Central Planning Authority

Agenda for a meeting of the Central Planning Authority to be held on **September 15, 2021 at 10:00Am, in Conference Room 1038, 1st Floor, Government Administration Building, Elgin Avenue.**

CPA/19/21

Figure 3 – Cropped image of the applicant's Authenticated High Water Mark Survey (Source: applicant's submissions).

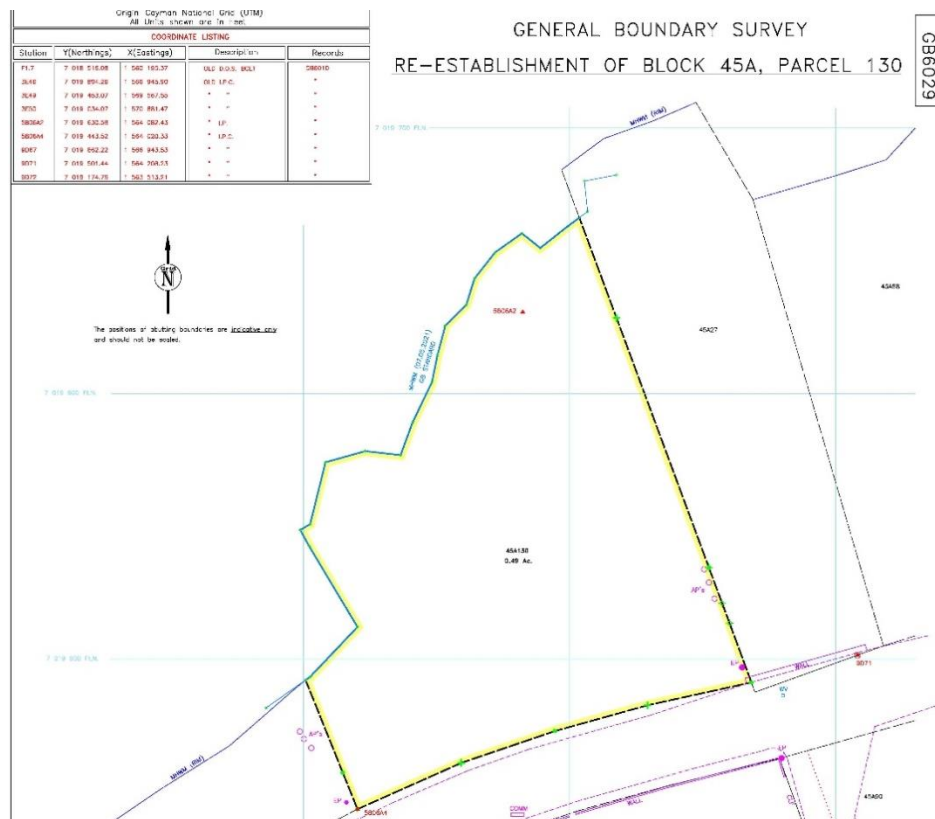
The Department notes from the plans submitted that the coastline is being referenced as ironshore. The coastline of the parcel is primarily a perched beach atop ironshore rather than a solely ironshore coastline. There are also pockets of beach with little to no ironshore in this location (see Figures 1 & 2). Much of the ironshore outcrops are also covered by water during high tide. Sand is naturally deposited onto perched beaches during storm events.

The Department is unable to reconcile the submission's High Water Mark Survey (Figure 3) with the coastline visible in aerial imagery and the DoE's site visit photos. Much of the boundary of the survey line appears to be in-water.

Given the climate change predictions for the region, including sea-level rise and increased intensity of storm events (including storm surge), coastal setbacks should not be reduced but instead should be treated as a minimum (as prescribed in the Development and Planning Regulations, 2021). Setbacks are one of a number of ways of enhancing the resilience of properties against the inevitable effects of climate change, such as coastal flooding and erosion, by ensuring that hard structures are not located in vulnerable locations susceptible to these hazards.
